257 Camden High Street
London, NW1 7BU

Basement Impact Assessment
Audit

For
London Borough of Camden

Project Number: 12336-50
Revision: F1

CONSTRUCTION SEQUENCE
251-259 CAMDEN HIGH STREET.
4352/SK/160520/TKL/00

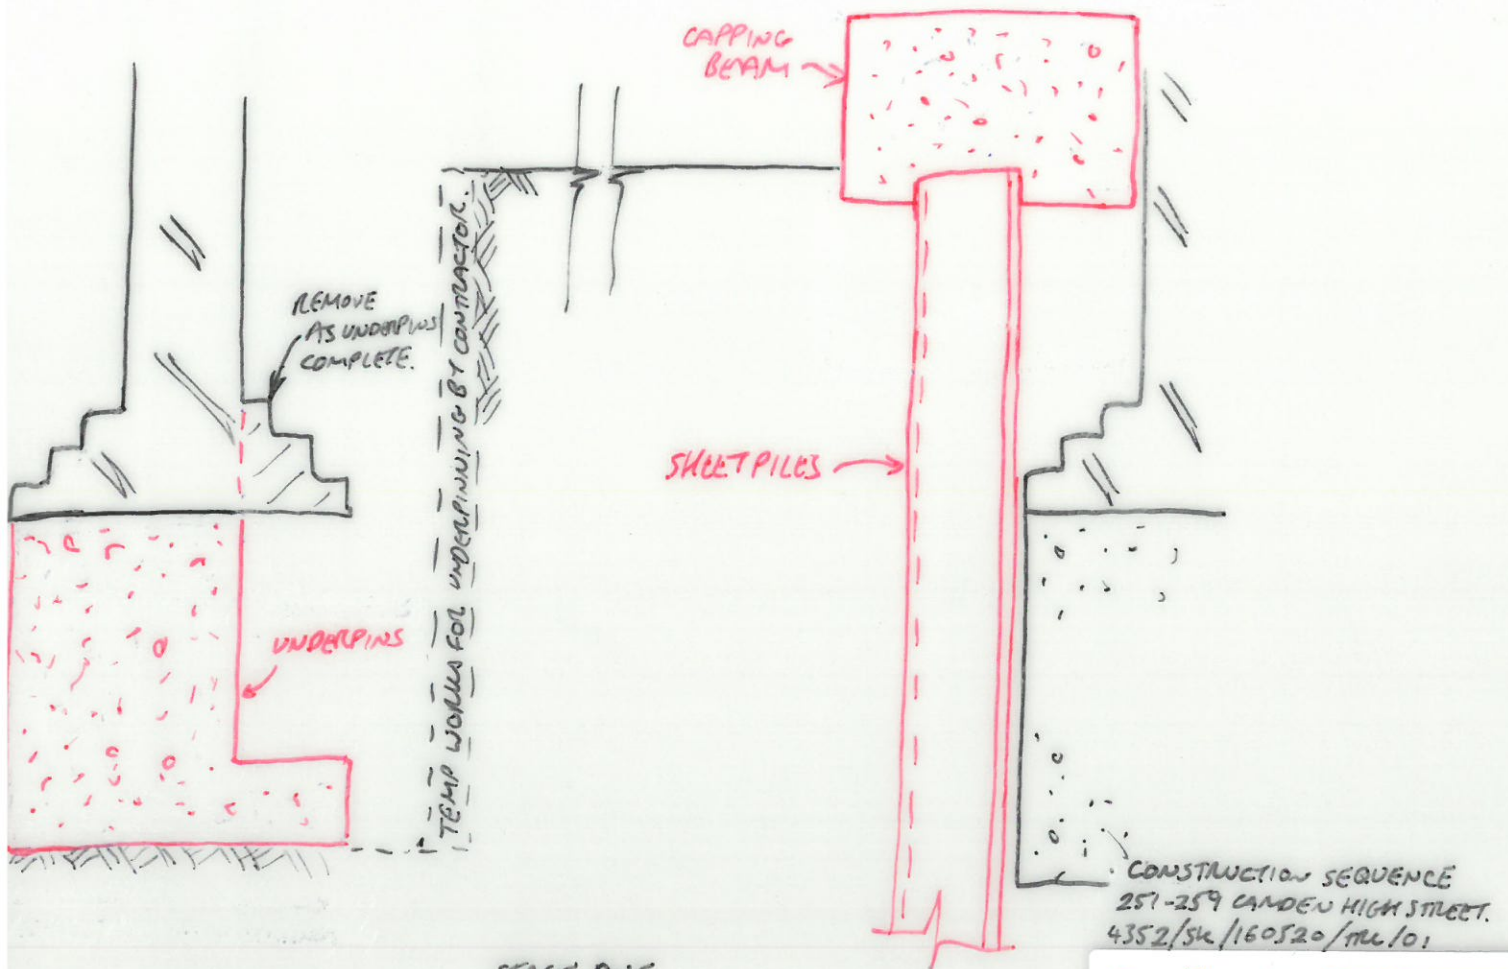
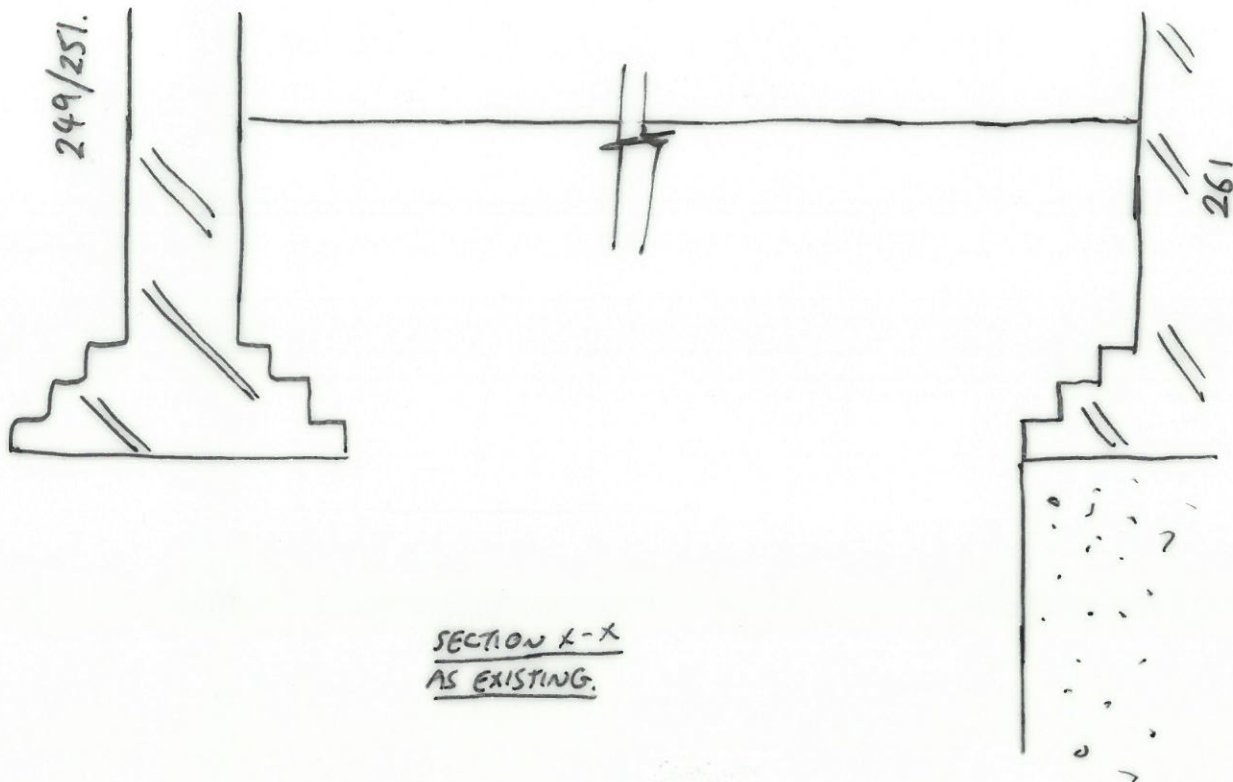
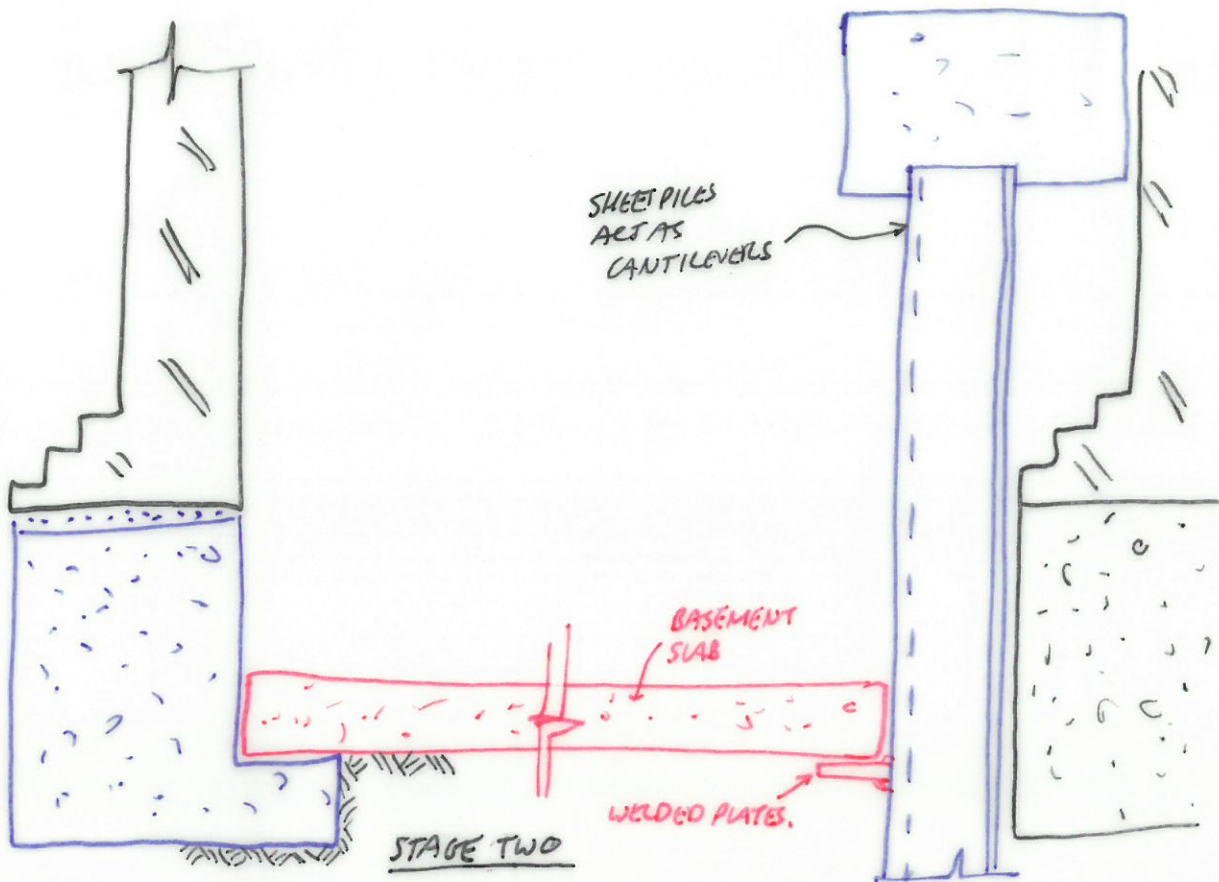
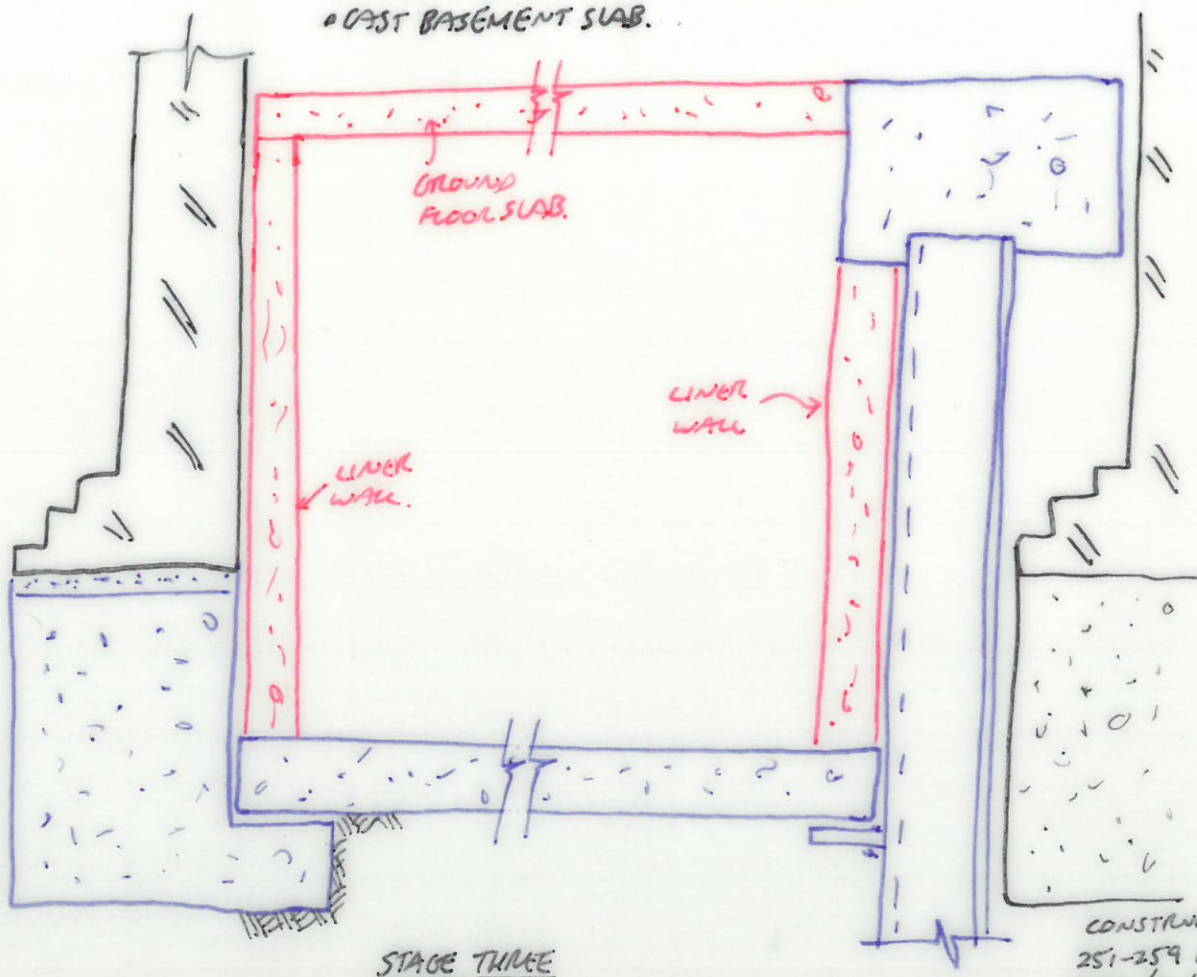
- 4.11. Reference is made to structural design by the engineers Walsh Associates. Suitable outline discussions on construction methodology and recommendations for undertaking underpinning is provided in the BIA, along with outline sketches (refer Appendix 3). Detailed methodology, sequencing and propping arrangements should be presented in a BCP.
